Project
10 Romney Road
Hayes UB4 8PU

Title
Existing & Proposed Site Plans

Drawing No
2039-AR-07-002
Rev
A

02 | PROPOSED SITE PLAN
07-002 | SCALE 1:150 @A3

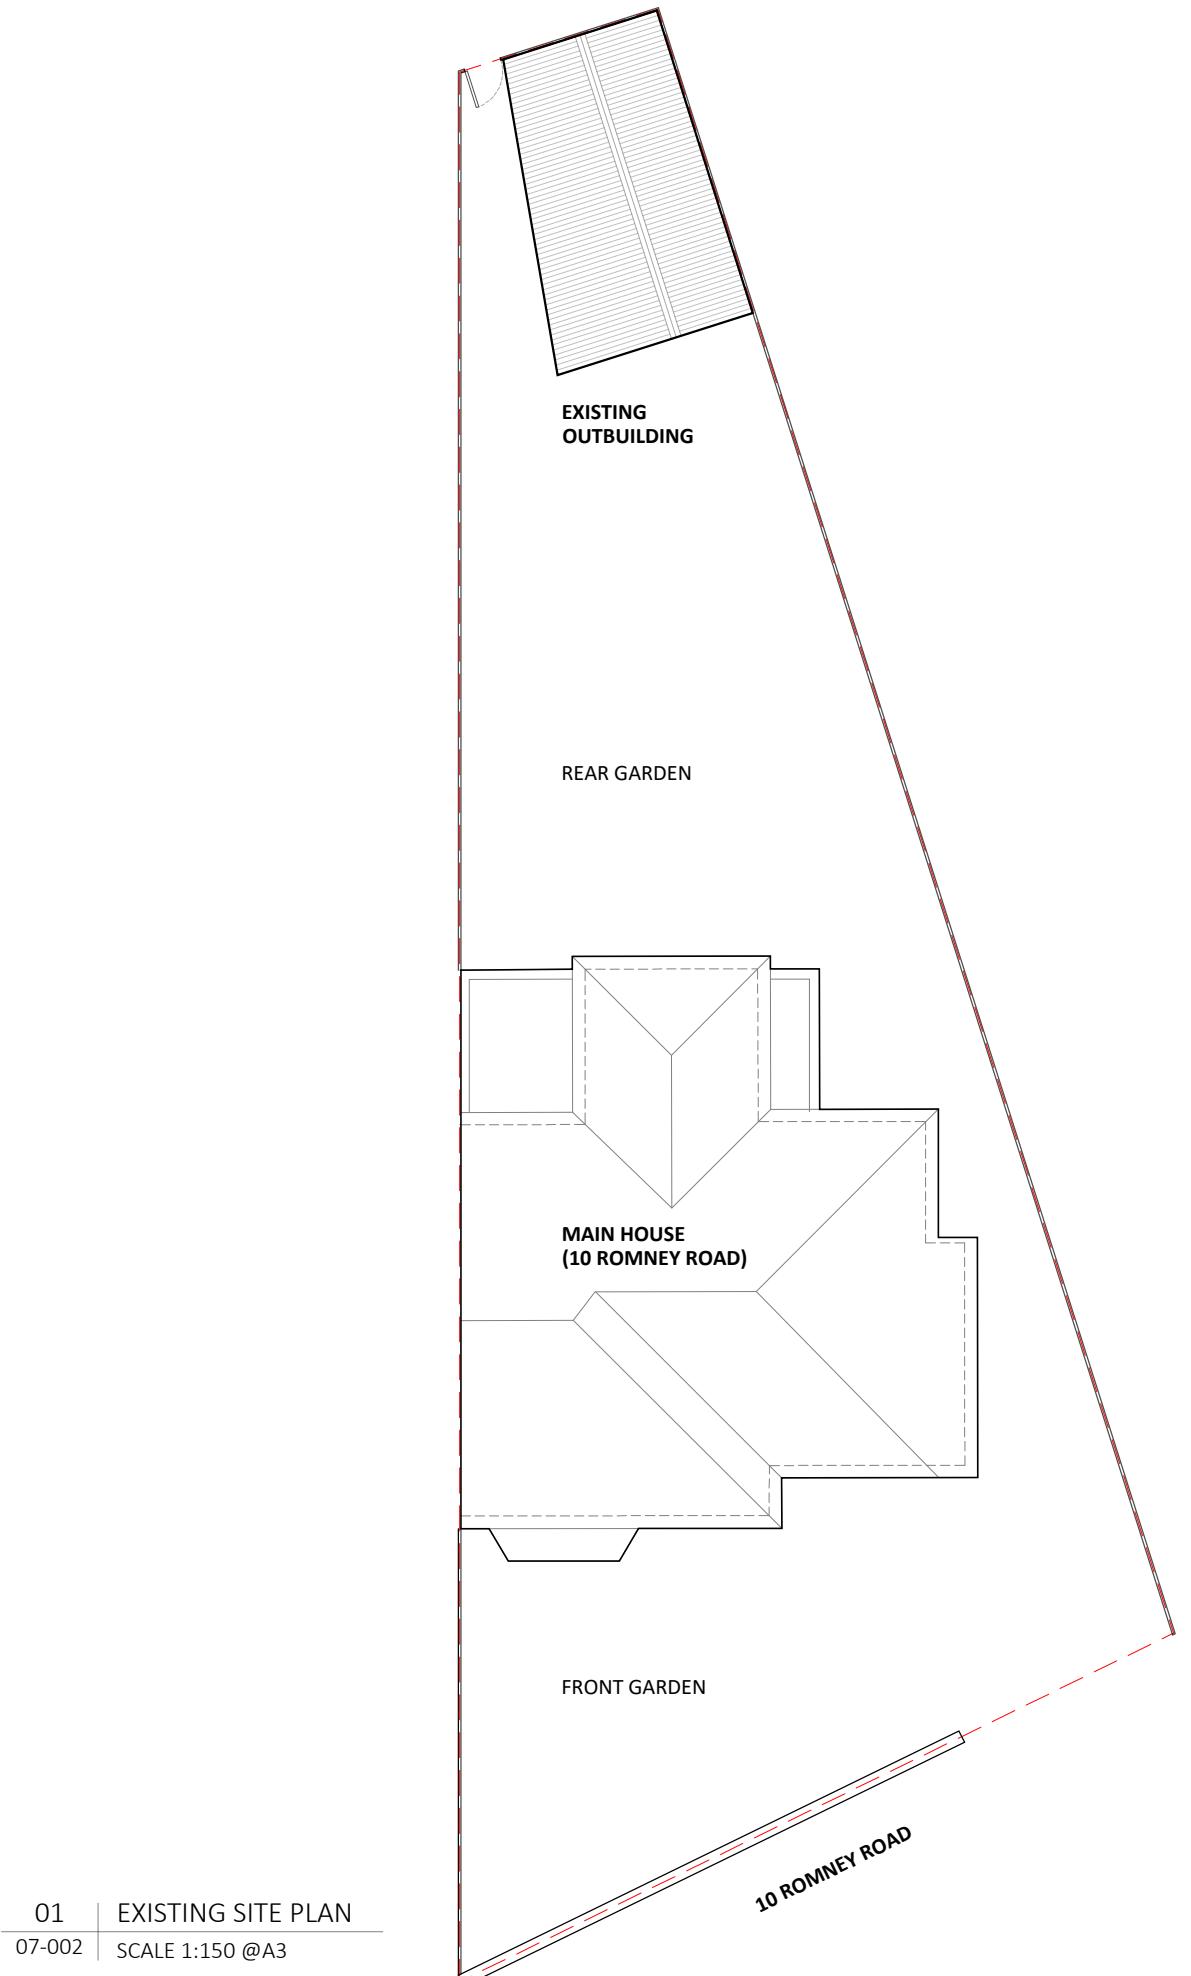
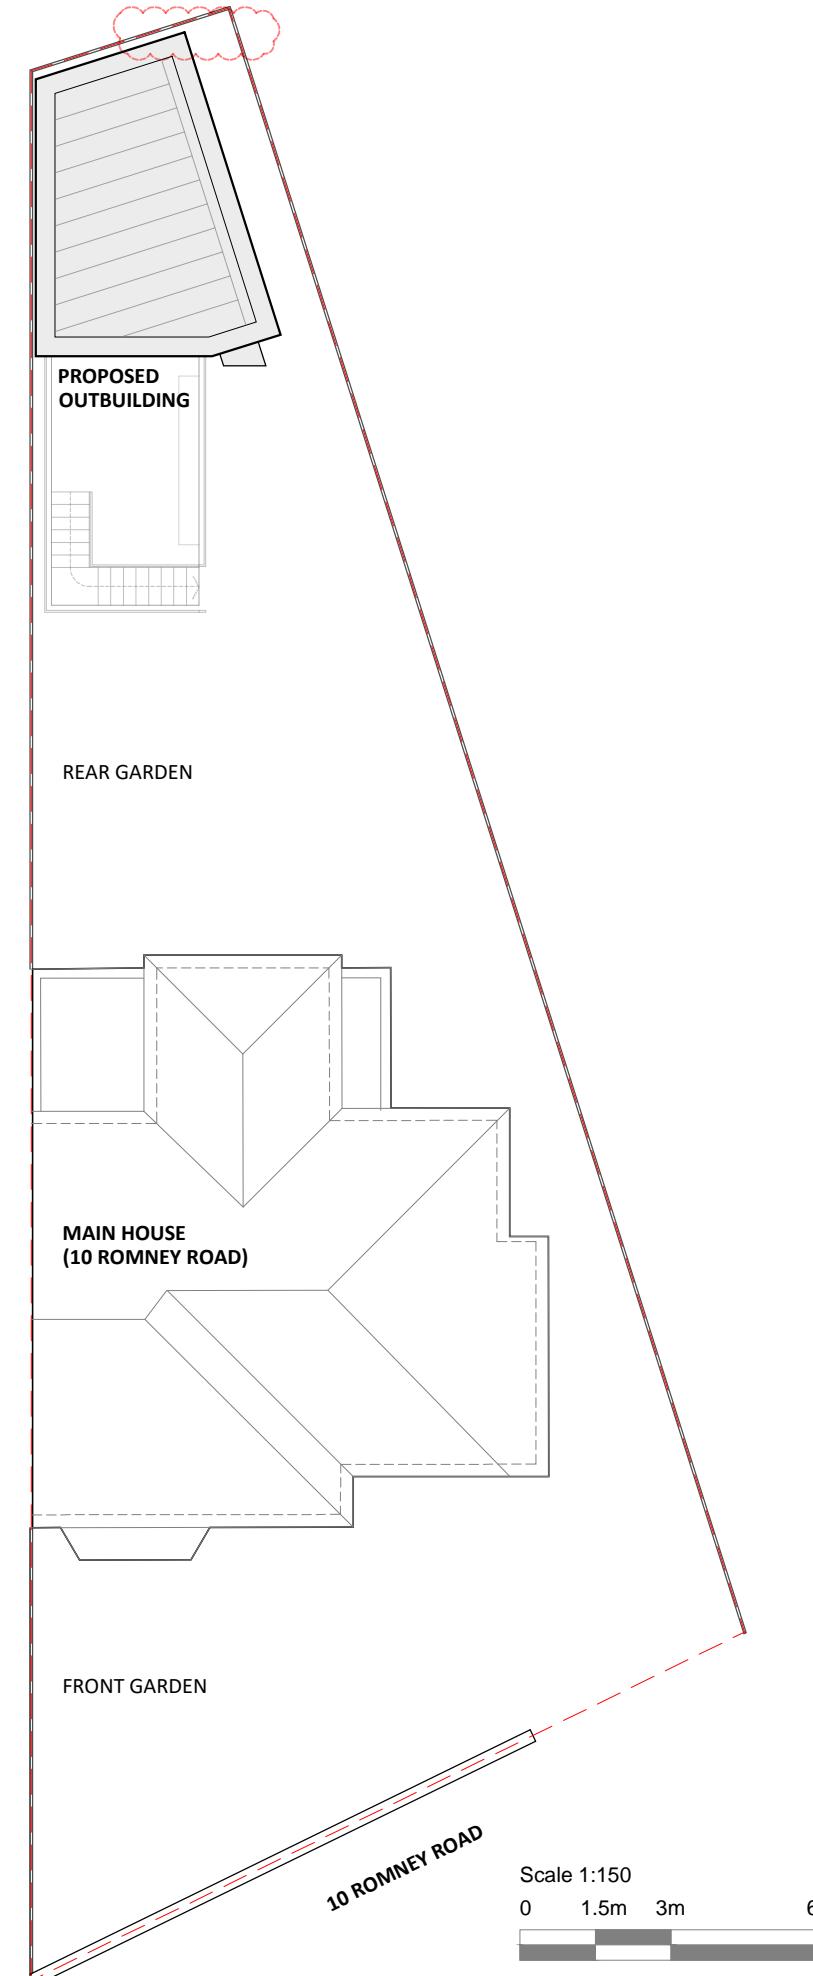
a	16.04.25	timber gate removed	IC
-	09.12.24	issued for planning.	IC
